Access Compliance Report Public Rights-of-Way (Pedestrian Signals)

Main Street: **E_CHAPMAN_AVE** Cross Street: **S_HEWES_ST** Location: **SE**

ADA ID: **SGAT210929131625** Signal Type: **One Push Button-Non APS** Overall Compliance: **No** Severity Scores: **BTN 1: 35** **BTN 2: N/A** **No BTN: N/A**

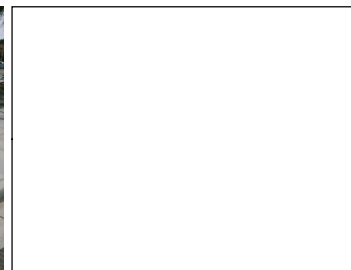
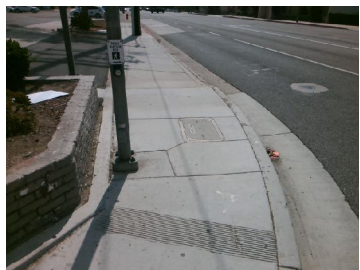
OC Std/PROW: R404.2, R404.3, MUTCD 4e.08

Possible Solutions: Replace Signal Push Button With APS Button. Remove and Replace Clear Space.
